Inspection Acceptance and Sign-Off Form

Project Name:	Hope Bay Project
Description of Area Inspected:	Doris North-North Dam Project: 5/8" Aggregate crush capping.
Date of Inspection:	January 20, 2012
Parties Present at Inspection	Mike Price Site Engineer; Nuna Logistics Ltd., John Kurylo EIT; Staff Consultant; SRK Consulting Inc. <i>Ben Vorstermann</i>

NOTES: - SEE JAN 20 th , 2012 CLEANING INSPECTION ACCEPTANCE FORM.		OWNER: NEWMONT NORTH AMERICA Hope Bay Mining Ltd.		PREPARED BY: NUNA Contracting Ltd. 9839 - 31 Avenue Edmonton, AB T6N 1C5		NORTH DAM CONSTRUCTION	
		PROJECT: Doris North Project, Hope Bay, Nunavut		DRAWN BY: RMM		DRAWING TITLE: Cut/Fill Map -Status of 5/8" Excavation to FCM	
				SCALE: 1:250	DATE: Jan. 17 2012	DRAWING NAME (YYMMDD): SM 120117 NORTH DAM 5-8 EXC.dwg

NORTH DAM CONSTRUCTION
North Dam Alignment and
Outline of Key Trench

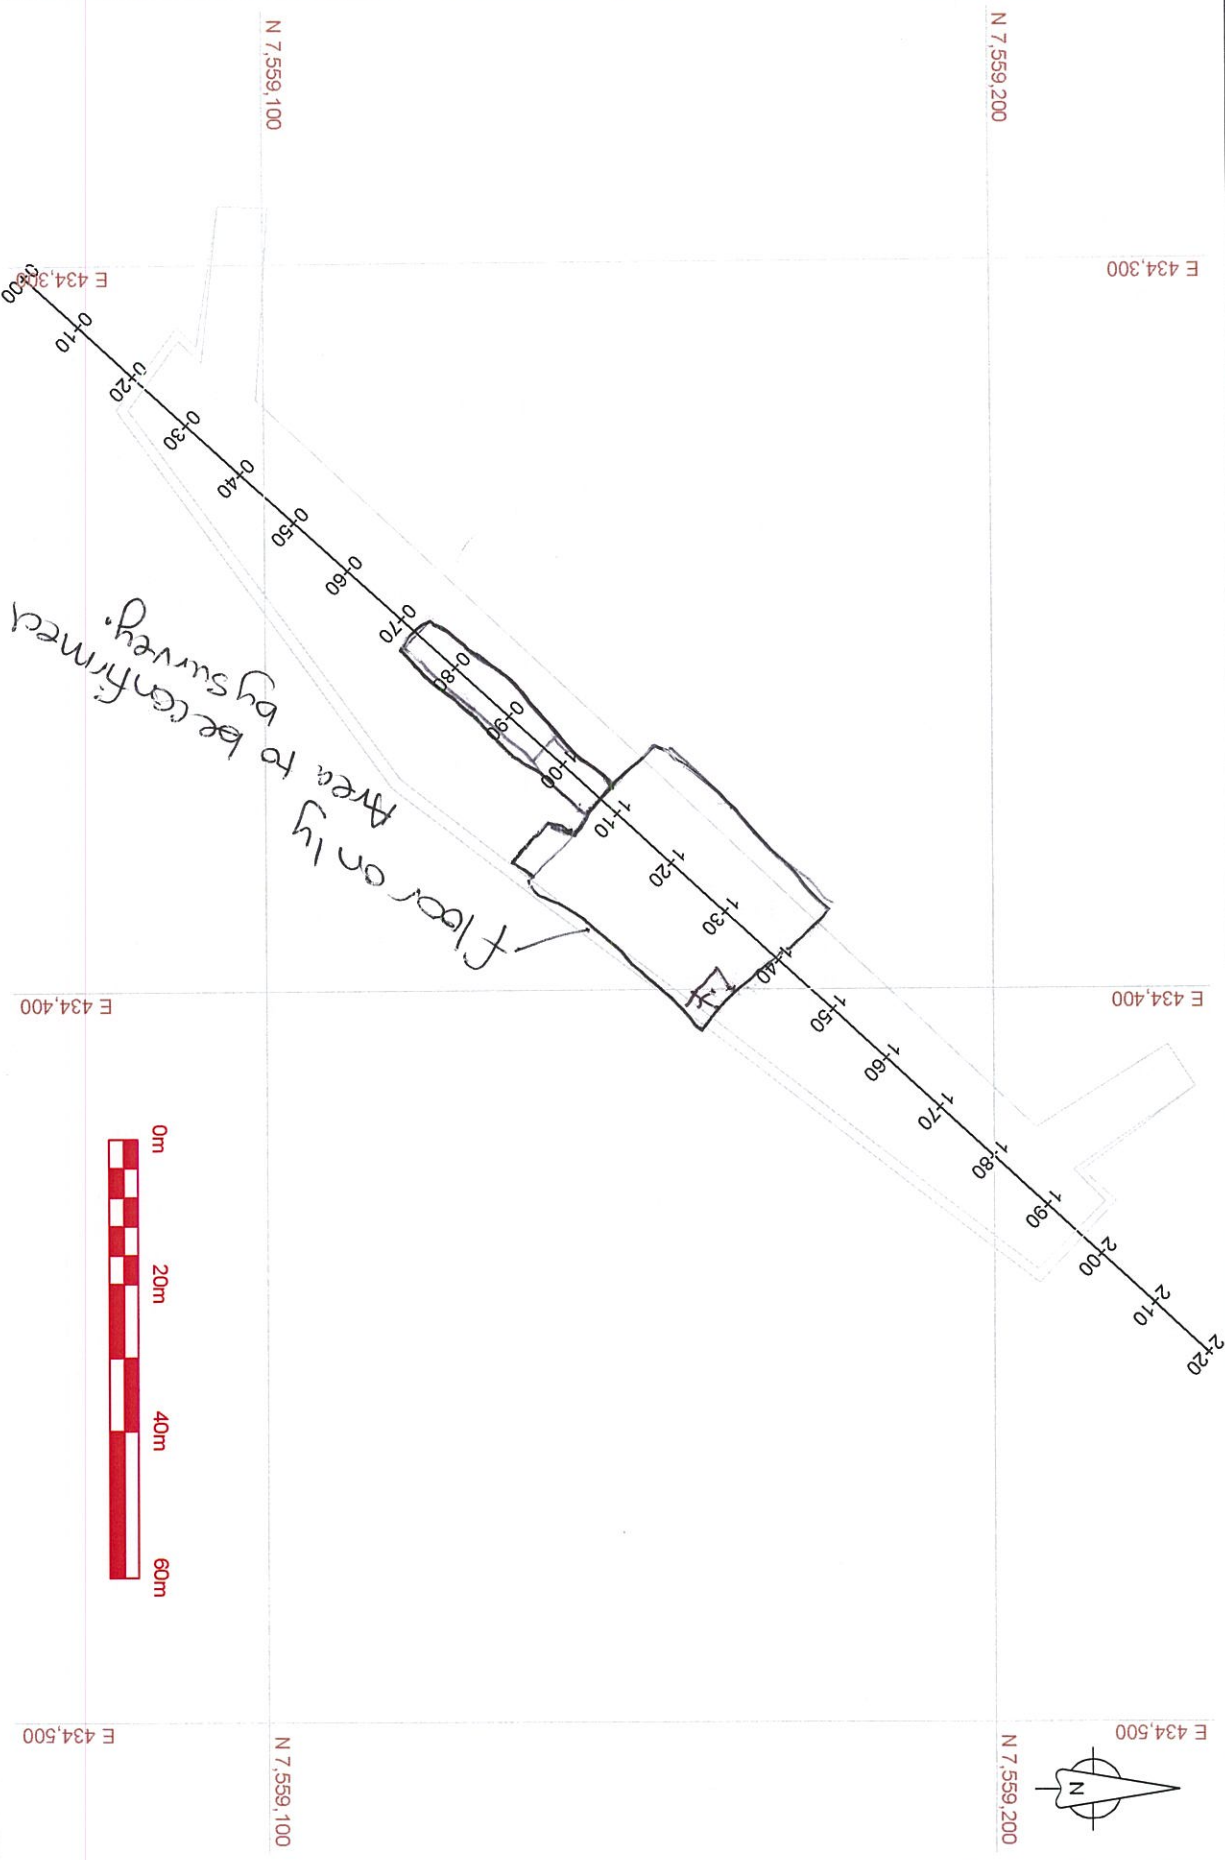
The designated "Dental cleaned" area has been found to meet the required engineering definition of cleanliness: free of snow, debris and ice build-up, and the previous placed lift has reached the desired temperature "Freezeback" for frozen core lift placement.

Placement has been approved for the section of the key trench between station ~1+07 and 1+40 from the downstream edge to the base of the fillet slope and the area previously excavated core material from station to . from where the truck drove. (2012/01/21).

See appended Survey drawing for details of extent.
sketch

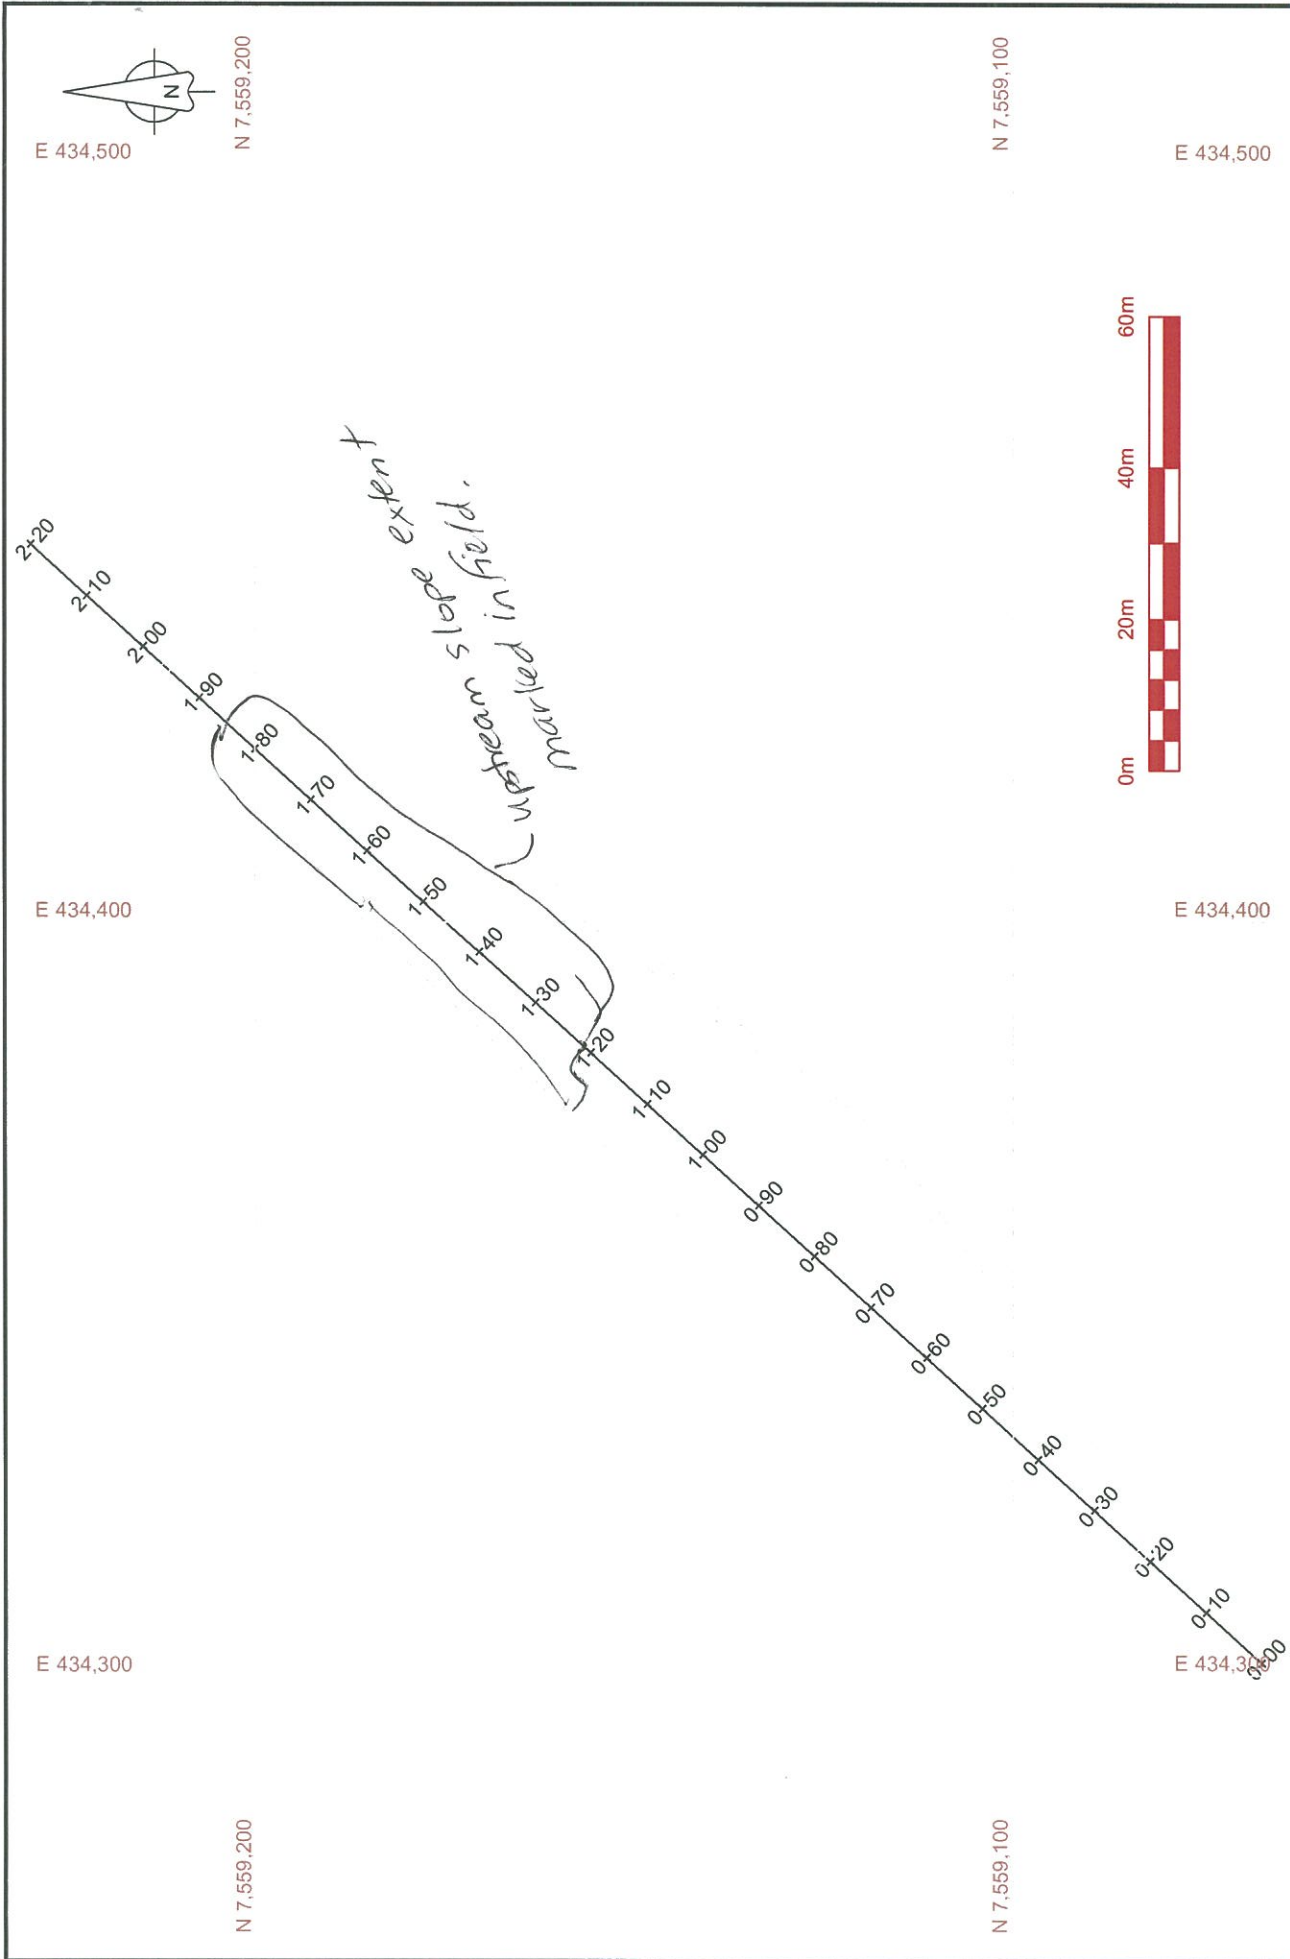
The designated "Dental cleaned" area has been found to meet the required engineering definition of cleanliness: free of snow, debris and ice build-up, and the previous placed lift has reached the desired temperature "Freezeback" for frozen core lift placement.

Placement has been approved for the section of the key trench between station 1+25 and 1+85.

See appended ^{sketch} ~~Survey~~ drawing for details of extent.

NOTES:	OWNER:	NORTH DAM CONSTRUCTION	
	PROJECT:	North Dam Alignment and Outline of Key Trench	
PREPARED BY:	NUNA Contracting Ltd.		DRAWING NAME (YYMMDD):
	9839 - 31 Avenue Edmonton, AB T6N 1C5		DE 120121 ND TEMPLATE.dwg
DRAWN BY:	GC		DATE:
	1 : 1000		2012/01/26

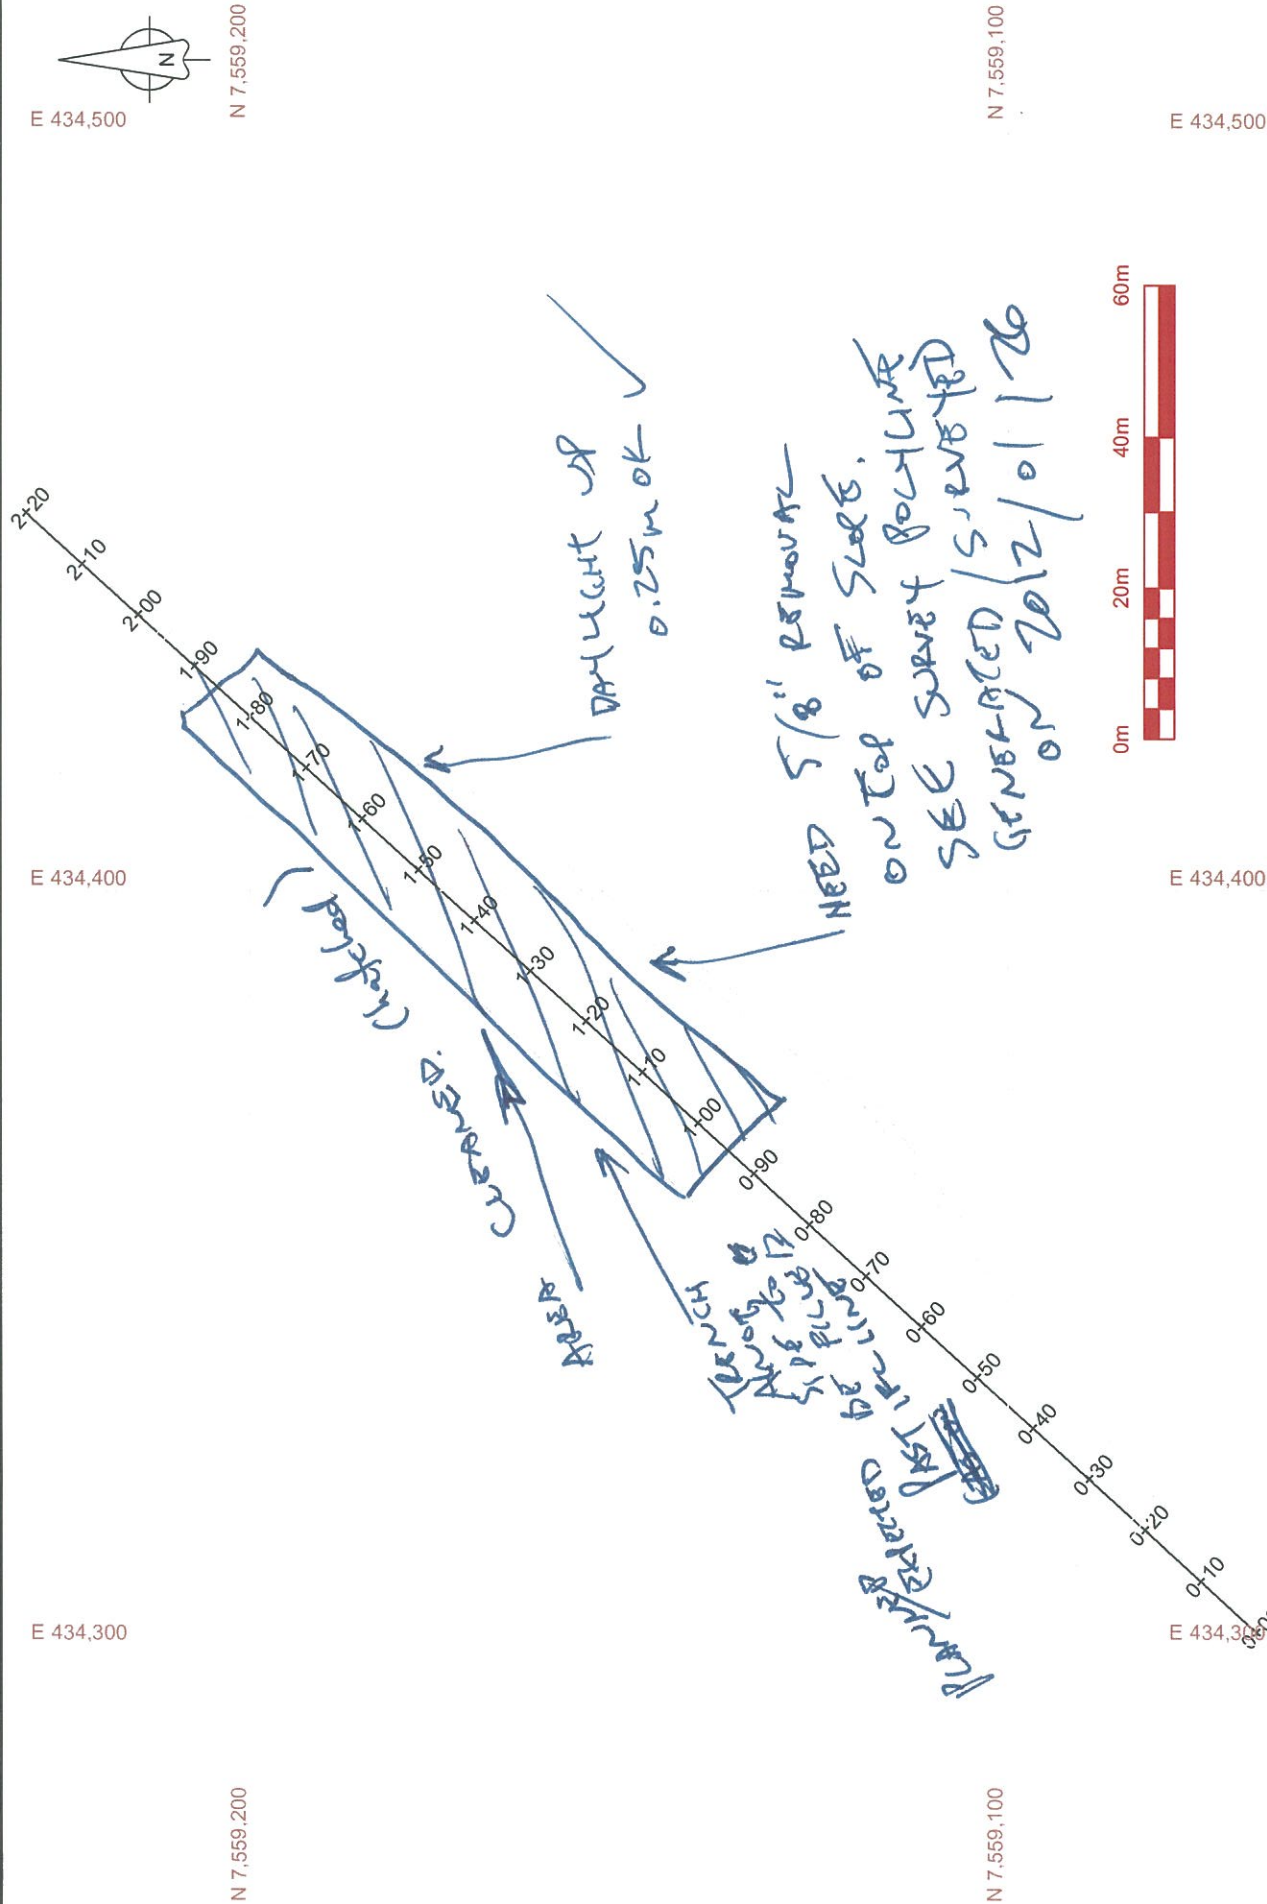
The designated "Dental cleaned" area has been found to meet the required engineering definition of cleanliness: free of snow, debris and ice build-up, and the previous placed lift has reached the desired temperature "Freezeback" for frozen core lift placement.

Placement has been approved for the section of the key trench between station 0+95 and 1+90

Note: Placement approval is based on immediate placement of core product; extended breaks in placement and changing weather conditions may result in additional cleaning.

(watch blowing snow today if placement stops).

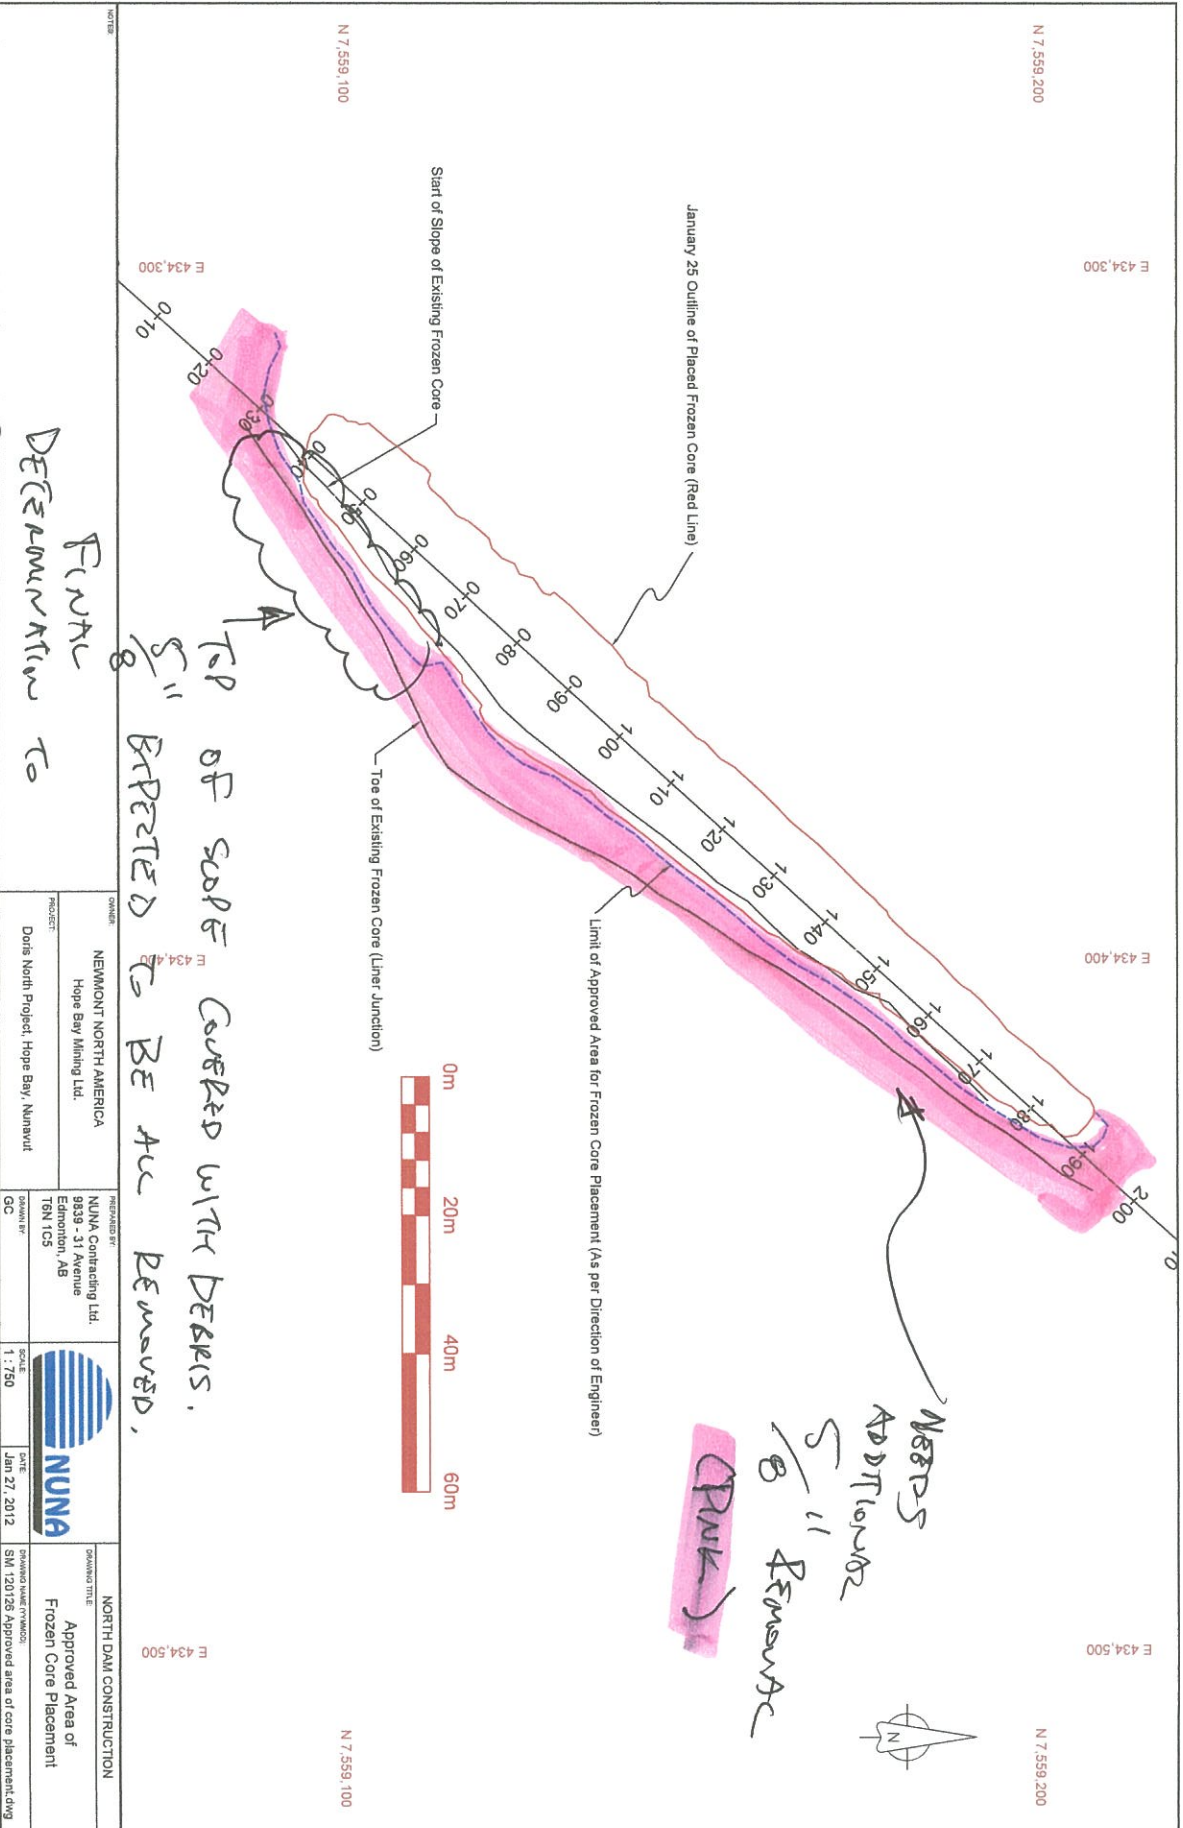
Comments:
<p>The 5/8" aggregate crush capping has been removed to the engineering's satisfaction to expose the existing North Dan frozen core material placed last year in the area downstream of the dotted blue line on the attached status map.</p> <p>— REMAINING AREAS FOR 5" REMOVAL PRIMARILY on UPSTREAM SLOPE TO FILLET.</p> <p>— AREAS on BASE FROM 1+85 (+1+90) to 1+0+30 CLEARED OF 5" (See P. 1)</p> <p>Note: See appended Survey drawing for details of extent.</p>

NEEDS
ADDITIONAL
5' REMOVAL
(PARK)

TOP OF SLOPE COVERED WITH DEBRIS.
5' EXPECTED TO BE ALL REMOVED.

FINAL
DETERMINATION TO
BE MADE AFTER
AREA CULMINATED
